SEA DIKES NORTHERN PART OF VIET NAM (Red River Delta)

- Review -

Authors:
K.W.Pilarczyk
P.J.Eversdijk
G.Kant

May 1996

Figure 4.1 Different types of grouting

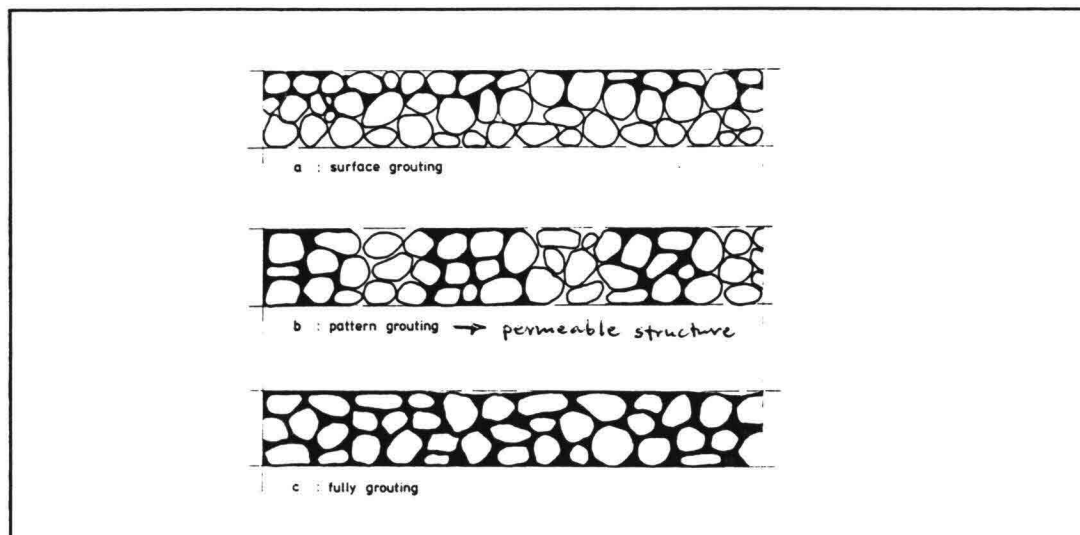
In case of fully grouting of (unstable) riprap the permeability will be drastically reduced, and also the surface roughness will be reduced, providing as a result of nearly no reduction of runup. In such case the pattern grouting (local grouting) with strips of concrete may somewhat help to increase the permeability, and thus, the reduction of runup (see figure 4.1).

Figure 6.1 Design Cross-sections in Quang Ninh Province

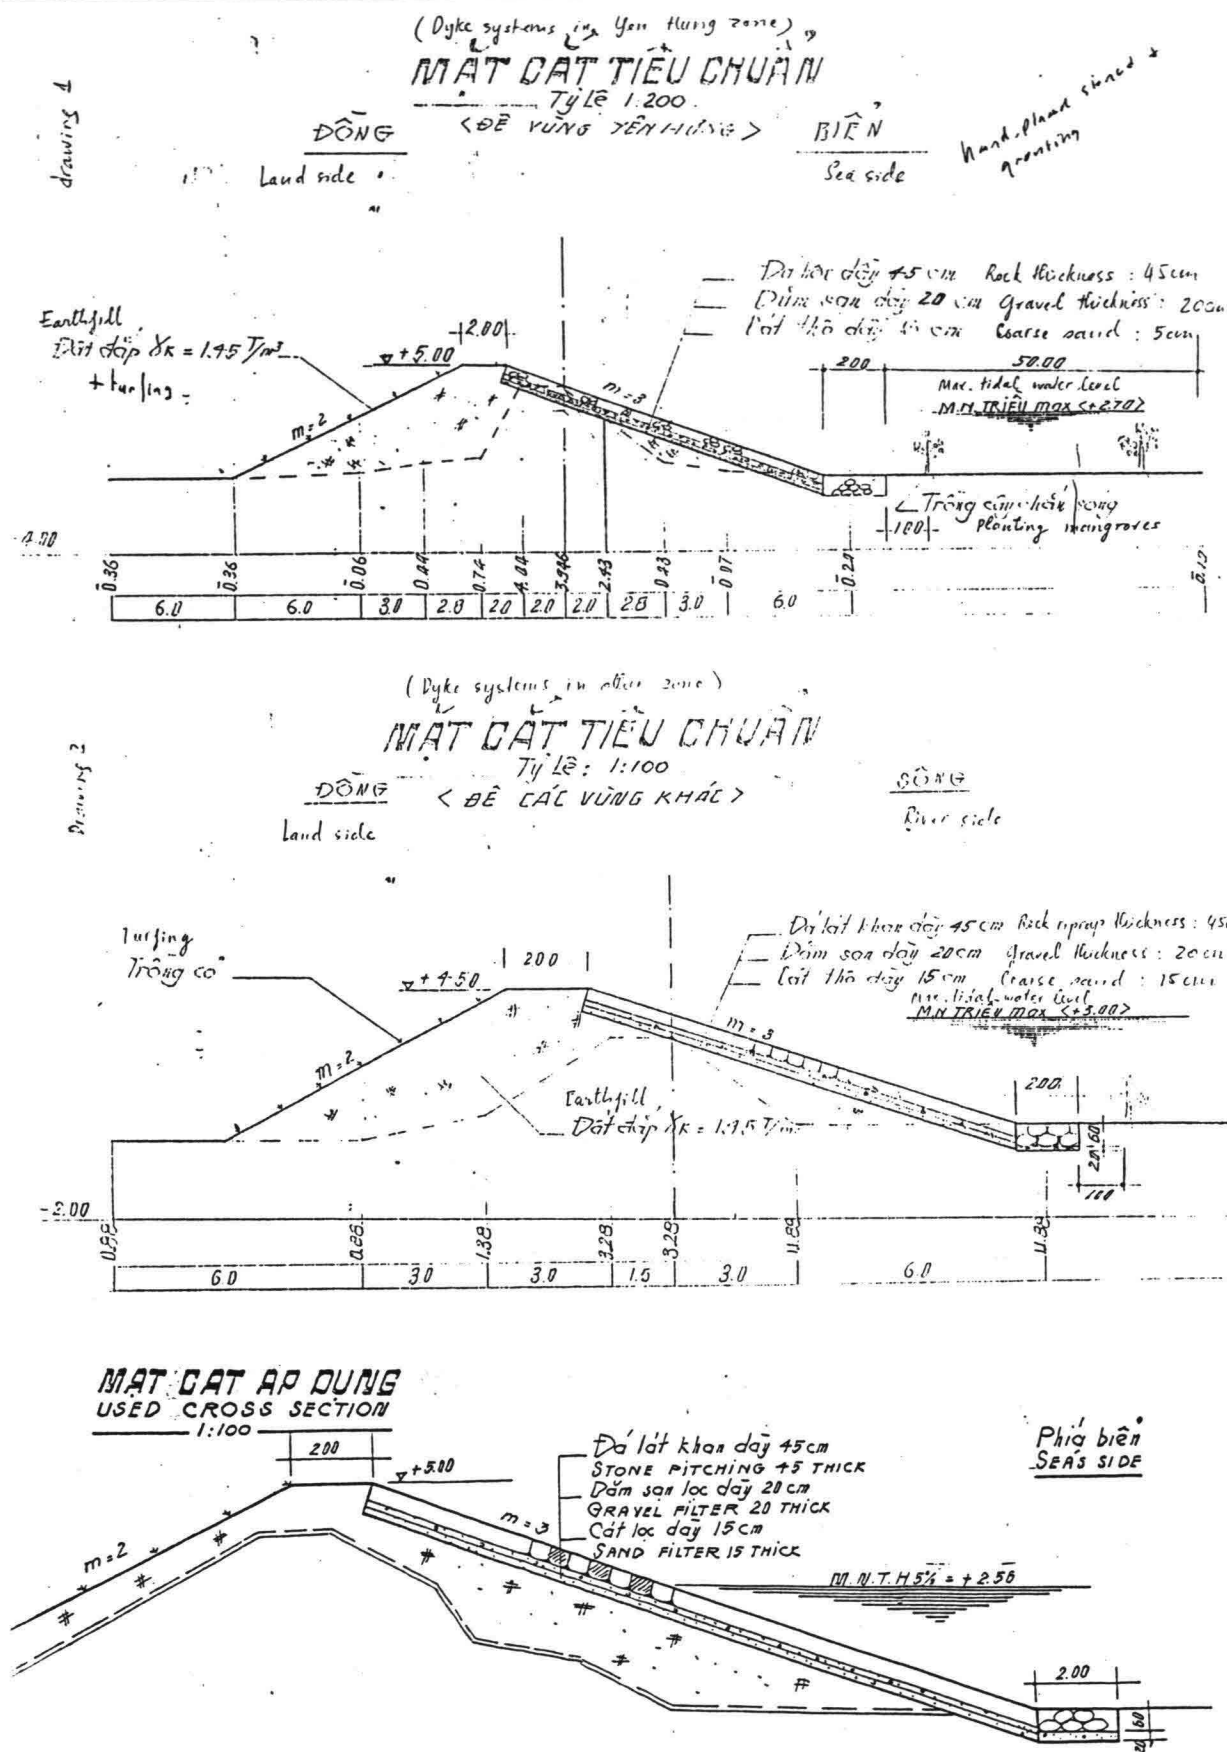
- What does it mean in report [1], "reduction of stone size by 25%", when calculating stone size?

Figure 7.1 Typical cross-section of sea-dike no. I - Hai-Phong Province

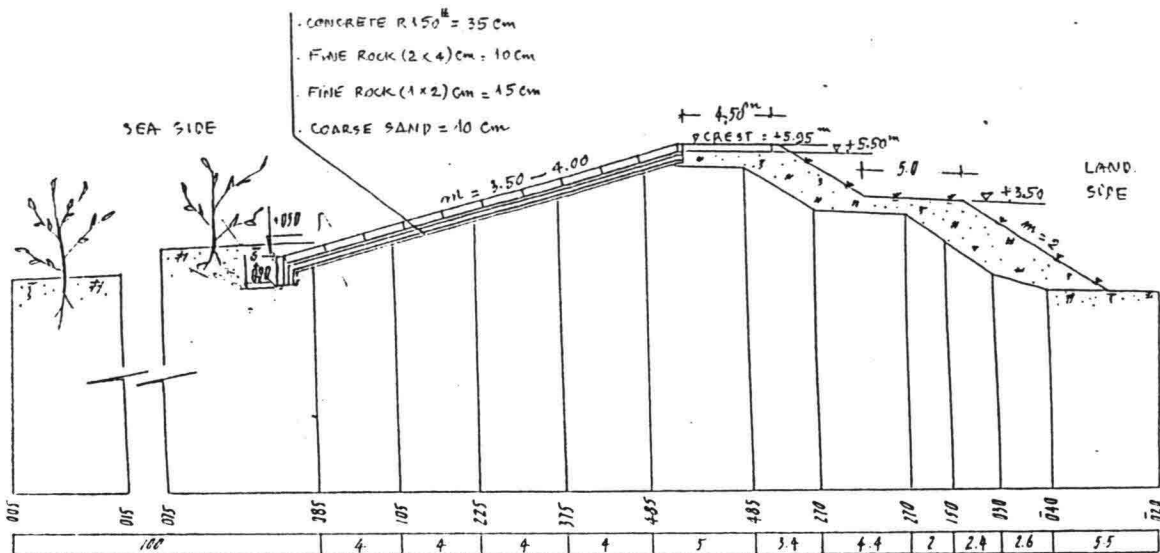
- The design drawings, especially concerning toe protection, need further improvement. The present toe construction seems to be insufficient.
- Proper specifications for execution should be prepared.

- Extra attention should be given to the execution of the transition between the two revetment types.

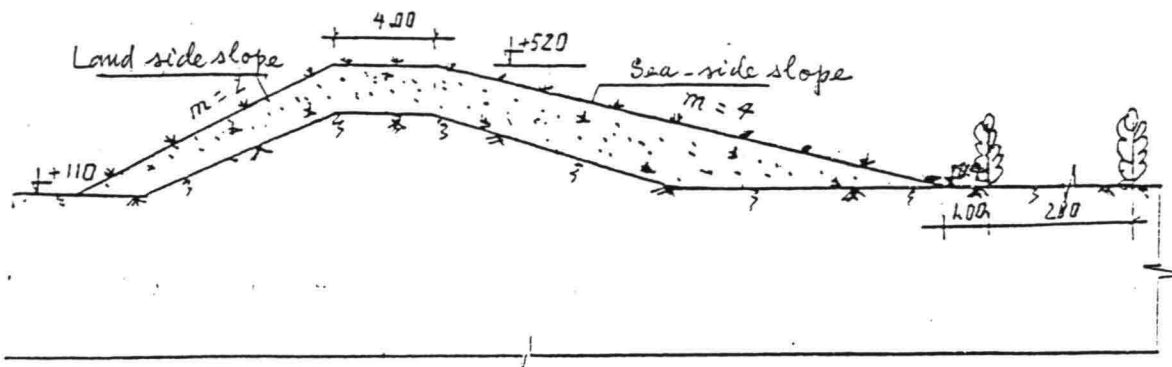
- The connection between the revetment and the layer of clay on the crest is insufficient; due to rainfall and overtopping water clay will erode to filter construction under pitched stone revetment).
- Construction of toe protection in lit 1 only vaguely conveyed. The construction appears to be insufficient.
- A sufficient layer of clay with a vegetation of grass is important to prevent damage due to overtopping.
- Above the calculated crest height an extra size is needed due to settlement of the subsoil which will occur due to load of earthfill.
- Because uncertainties concerning calculation of the wave height, the calculated stone size is also uncertain.
- In the report [3] riprap is calculated while on the drawings a pitched stone is shown! It must be clear what is applied: riprap or pitched stones. These are two different revetments which should be calculated by separate methods.

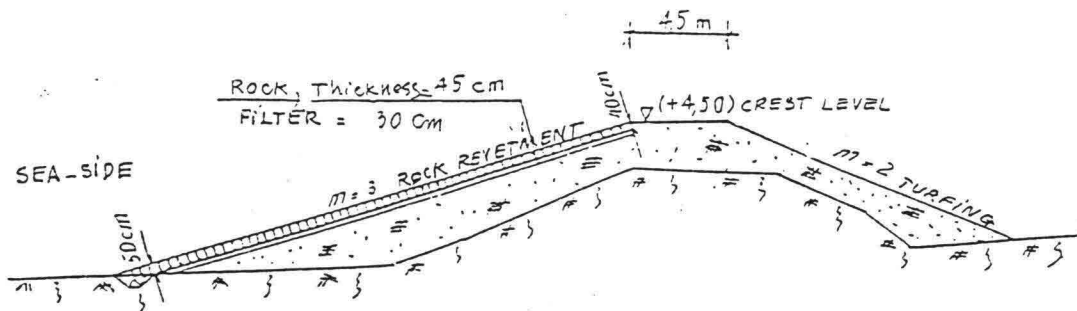
- The connection between the revetment and the layer of clay on the crest is insufficient; due to rainfall and overtopping water clay will erode to filter construction under pitched stone revetment).

- The remark given in the report [5] that "in case of using geotextile, we can replace conventional filter layer by geotextile", is only true for waves lower than 1, thus for estuary dikes.
For high waves often an additional granular layer is needed between the toplayer and geotextile, to reduce the hydraulic gradients at the interface with a sandy subsoil below the critical values.
